Bulletin No.: PIT6176
Published date: 05/15/2024

PIT6176 Front License Plate Screws Included in Kit Do Not Fit License Plate Bracket

Brand:	Model:	Model Years:	VIN:		Engine:	Transmissions:
			from	to		
Buick	Envision	2024	All	All	All	All

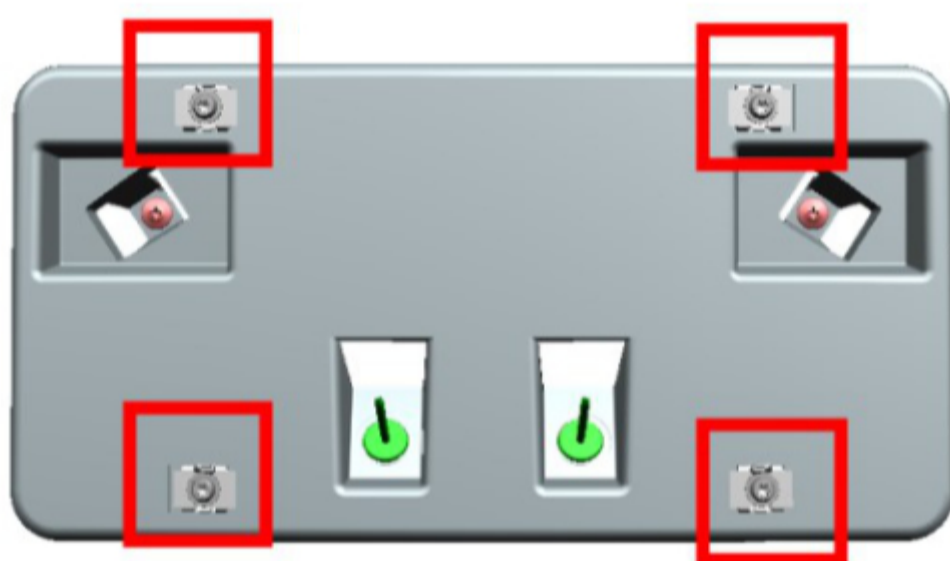
Involved Region or Country	North America
Additional Options (RPO)	VK3 - FRONT LICENSE PLATE BRACKET
Condition	Some technicians may find during pre-delivery inspection that the front license plate fasteners (highlighted in red below) that attach the license plate included in the front license plate kit, do not fit with the push nuts attached to the bracket.
Cause	The incorrect fasteners were included with the front license plate bracket.

Replace the M5 fasteners with M6 fasteners.

Description	Part Number	Quantity
M6 Fastener	11546571	4
